Landscape Protection Plan

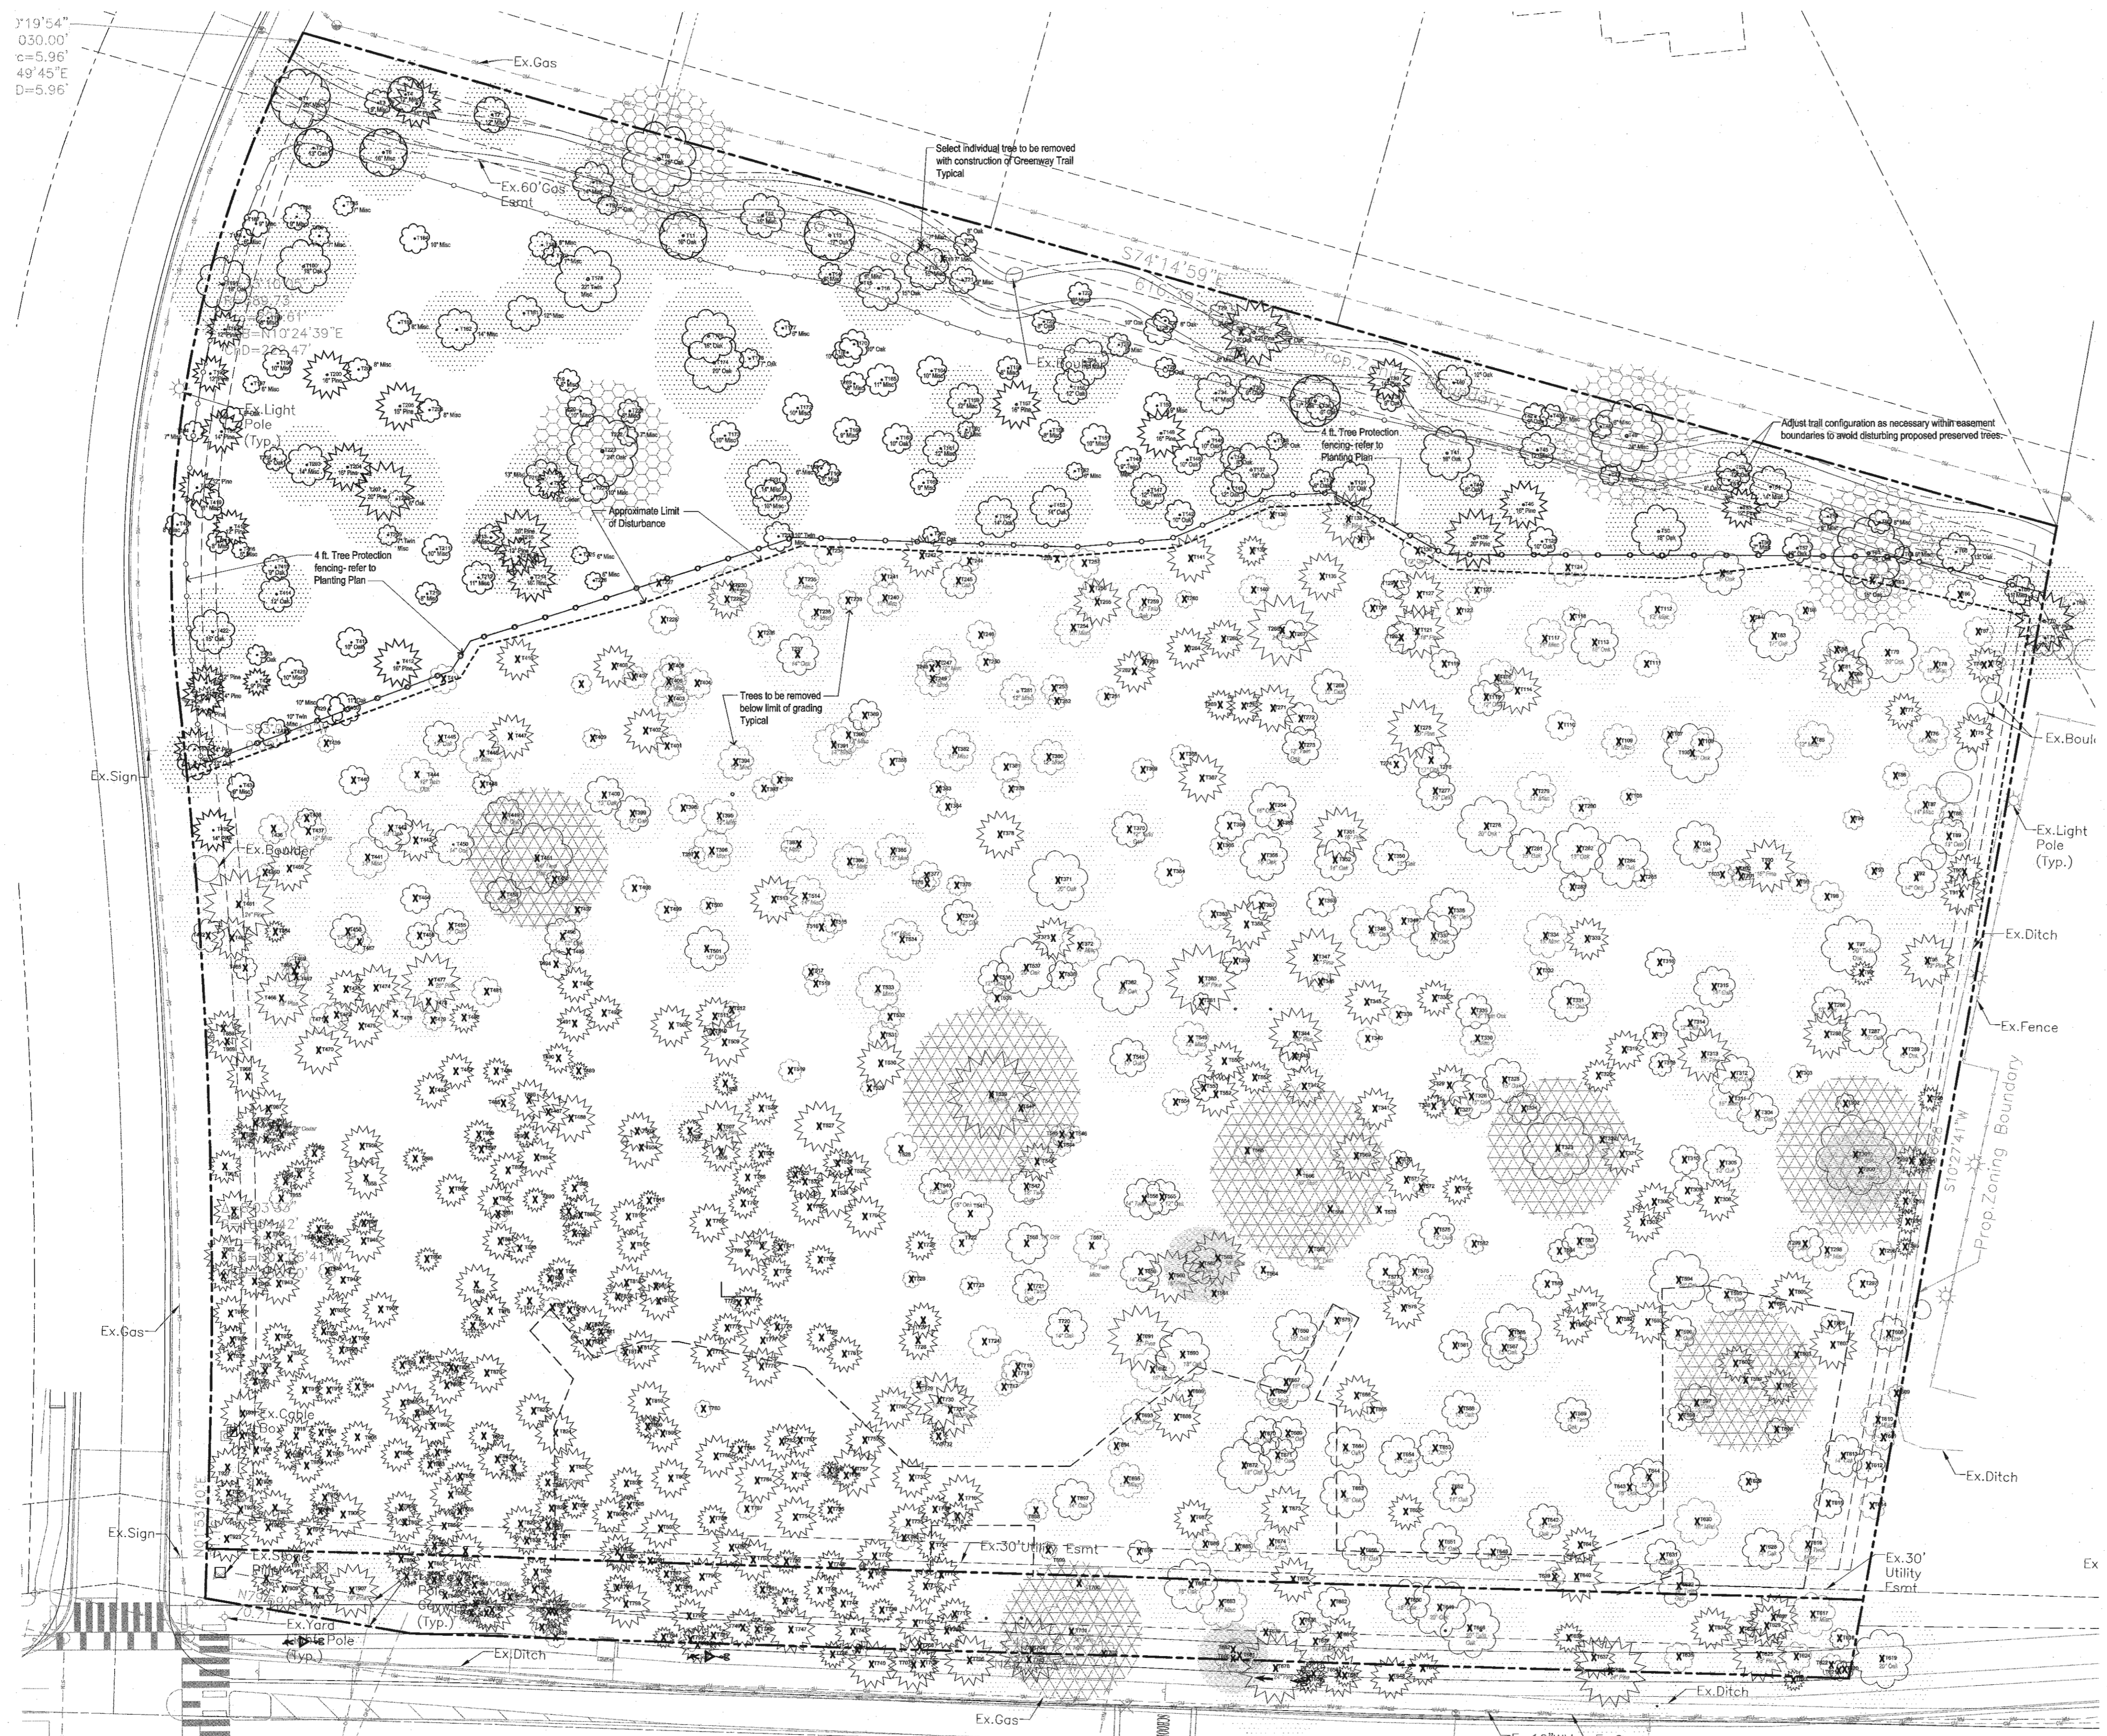
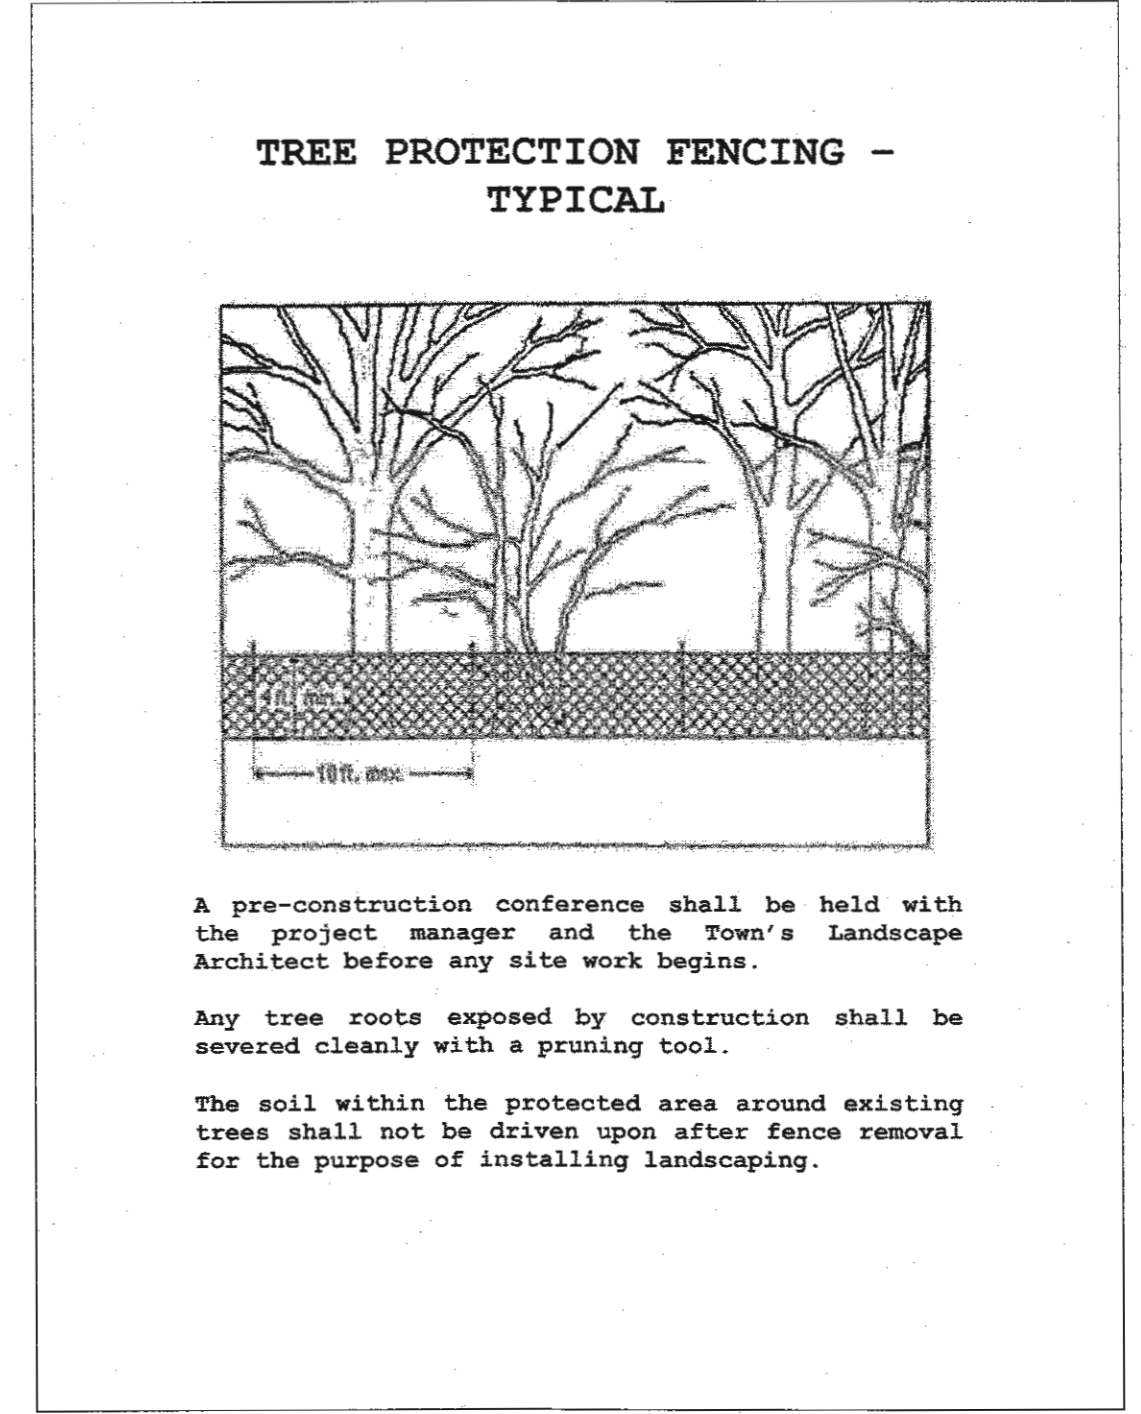
7. Our second concern is that virtually all of the trees have been removed from the construction site. We thought that the town's tree ordinance mandated the protection of significant trees and tree canopy. It seems like the tree buffer sought by the neighborhood and approved by the developer was not kept in place.

8. Will there be significant landscaping and plantings on the completed site that will buffer the residential neighborhood from the noise and lights of the Retirement Residence?

Town Staff Response: Please see the attached approved landscape plan. The development has a 30 percent tree canopy requirement.

Town Staff Response: Please see the attached approved landscape plan. The development has a 30 percent tree canopy requirement.
